22 March 2024

Venetin Aghostin Senior Development Planner Fairfield City Council

ADDENDUM TRAFFIC & PARKING STATEMENT IN REPLY TO COUNCIL'S RFI LETTER PROPOSED RESIDENTIAL FLAT BUILDING & TOWNHOUSES DEVELOPMENT 400-404 CABRAMATTA ROAD WEST, CABRAMATTA, 2 ORANGE GROVE ROAD, CABRAMATTA, AND 6 LINKS AVENUE, CABRAMATTA (DA NO. 260.1/2023)

Figure 1: Intersection Network Layout

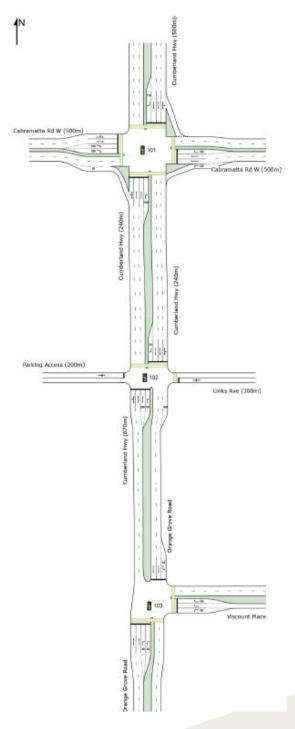
Refer to Figure 1 on the following page, showing the intersections network layout controlled by traffic signalling systems. Cabramatta Road West, Cumberland Highway, Orange Grove Road and Viscount Place have divided carriageways, with three through traffic lanes in each direction for Cabramatta Road West, Cumberland Highway and Orange Grove Road, and two through traffic lanes for Viscount Place in each direction. Links Avenue has an undivided carriageway with one through-traffic lane in each direction.

A post-development SIDRA intersection performance modelling analysis was then undertaken for the subject intersections, and it was modelled as the proposed network layout as shown in Figure 1 on the following page.

Figure 2: Development Traffic Distribution on the Surrounding Road Network - AM Peak

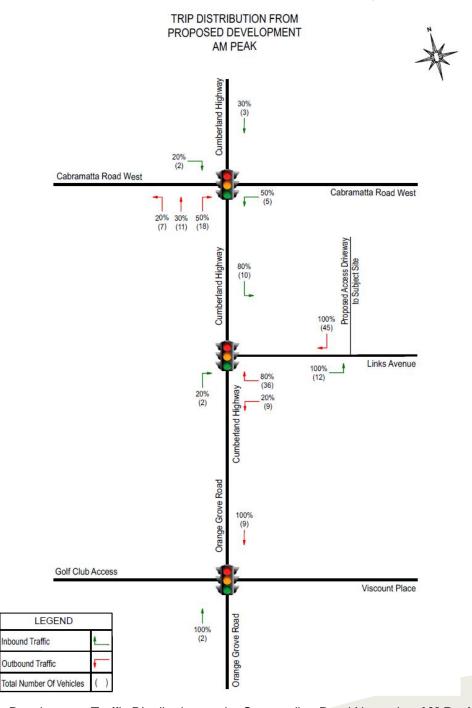
These assumptions will result in the development trip distribution shown in Figures 2 and 3 for relevant traffic movement and modelled intersections.

Appendix E – Updated Vehicular Swept Paths (Heavy Vehicle access)

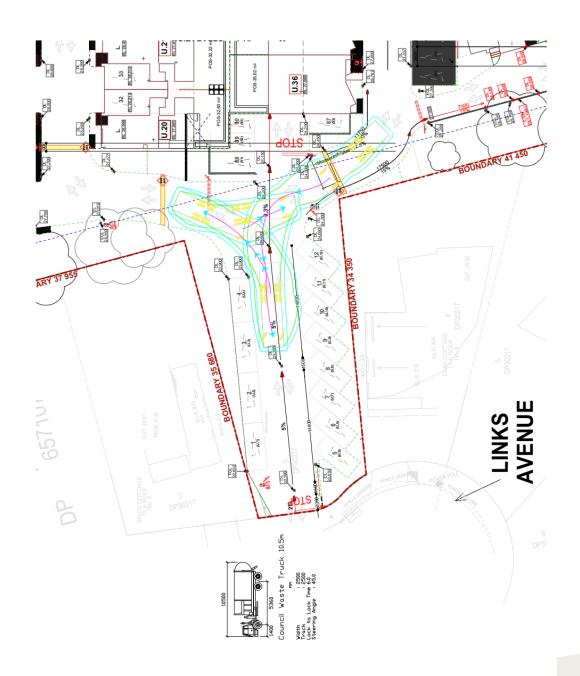
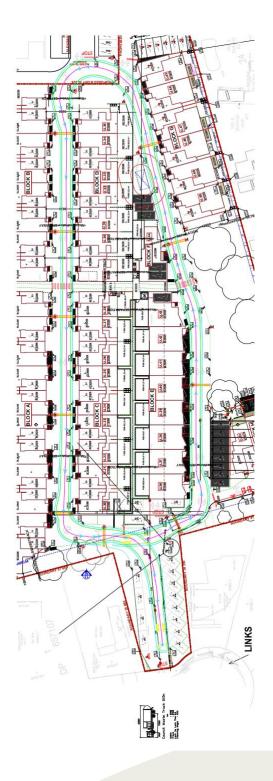
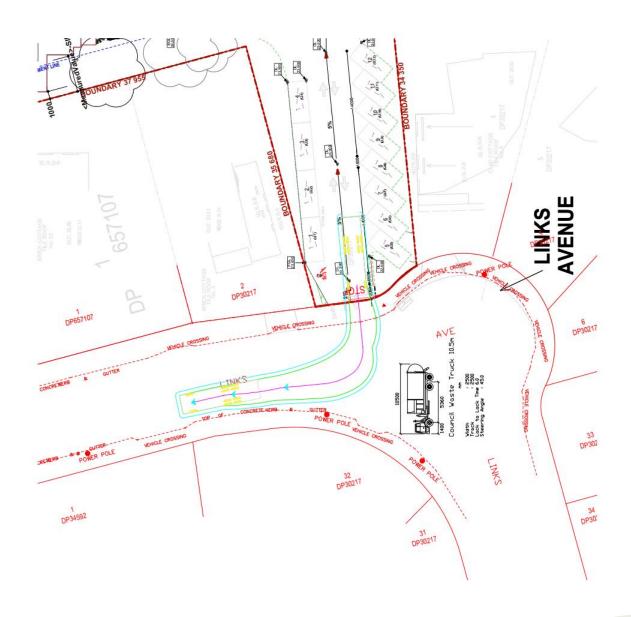
- c) Vehicular swept paths have been undertaken at the site access driveway demonstrating a HRV entering and exiting the site in a forward direction, as well as manoeuvring throughout the internal circulation roadway. Refer to **Appendix 'E'** for heavy vehicle swept paths. In addition, swept paths have been carried out showing a B99 passing a B85 passenger vehicle simultaneously at the access driveway as well as at intersection areas. Refer to the updated vehicle swept path plans attached in **Appendix 'C'**.
- d) A Loading Management Plan (LMP) has been prepared by Hemanote Consultants to address the frequency and type of vehicles expected to service the site and utilise the on-site loading bay. The LMP is provided separately from this statement.

Appendix J – Proposed On-Street 'No Stopping' Signage & Line-Markings Plan

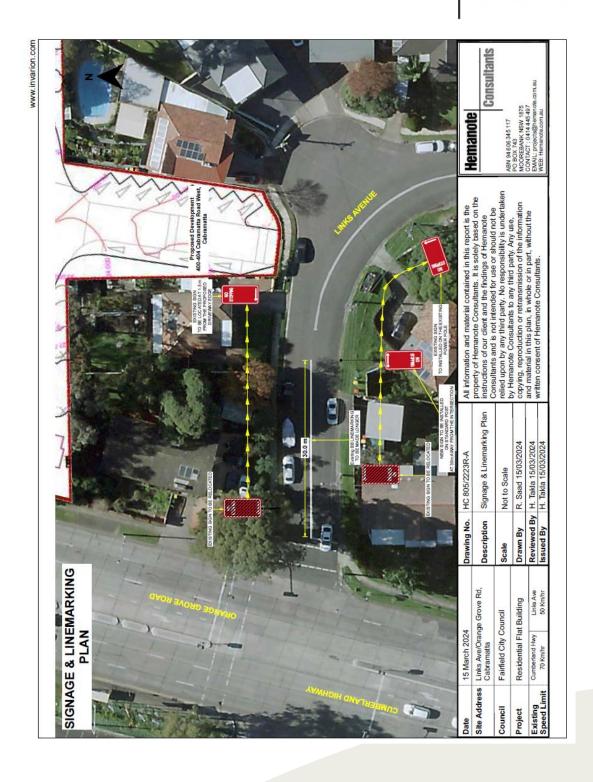
- a) a. It is recommended to extend the existing 'No Stopping' signage located along the northern and southern sides of Links Avenue, between the bend on Links Avenue and the intersection with Orange Grove Road. This will mitigate potential traffic impacts on residents on Links Avenue, preventing congestion from vehicles entering and exiting the street as well as the site driveway. This is as demonstrated in **Appendix 'J'** of this statement.

b) The proposed development layout has been amended to provide 'STOP signage at the egress point from the site into Links Avenue, giving priority to traffic travelling along Links Avenue, and in accordance with Clauses 1.5.1 viii. and xi. of SSDCP. It is recommended to extend the existing 'No Stopping' signage located along both sides of Links Avenue, between the bend on Links Avenue and the intersection with Orange Grove Road. Further, there is the proposed extension of the existing road BB line marking to be 30 meters in length within Links Avenue at its approach to its signalised intersection with Orange Grove Road.

This will alleviate potential traffic impacts on residents on Links Avenue, preventing congestion from vehicles entering and exiting the street as well as the subject site driveway. Refer to **Appendix 'J'** for the attached aerial map of Links Avenue with the proposed signage and BB line marking extensions.

This includes signage to be provided at the end of the main access road into the site, showing 'Apartment Building All Traffic' with an associated right turn arrow. In addition, 'left-turn only' signage out of the basement car park for the RFB and left-turn arrows are to be provided. Refer to **Appendix 'J'** for the proposed signage plan.

Appendix K – Proposed On-Site Signage Plan (Traffic management measures)

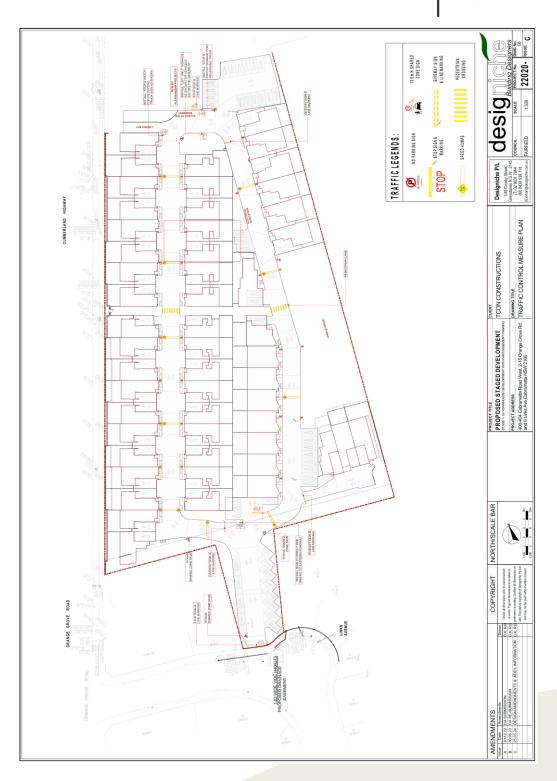
a) The proposed development plans have been amended to provide on-site signage between all conflict vehicle points, specifically between basement and at-grade level vehicular and pedestrian access. 'STOP' signage has been installed at the basement entry/exit point, giving priority to traffic within the internal circulation roadways, improving traffic flow and reducing vehicle conflict. Additional speed humps, dedicated pedestrian walkways, and '10 km/h Shared Zone' signage have been provided as calming measures to slow down vehicles and raise awareness of the presence of both pedestrians and vehicles on-site. This is as demonstrated in **Appendix 'K'** of this statement.

Traffic calming measures have been provided within the internal roads of the development layout as shown in the proposed on-site signage plan in **Appendix 'K'**, including speed humps and dedicated pedestrian walkways, with associated '10 km/h Shared Zone' signage, in order to reduce speed environment, raise awareness of the presence of pedestrians and children and increase safety for all users of the carpark.
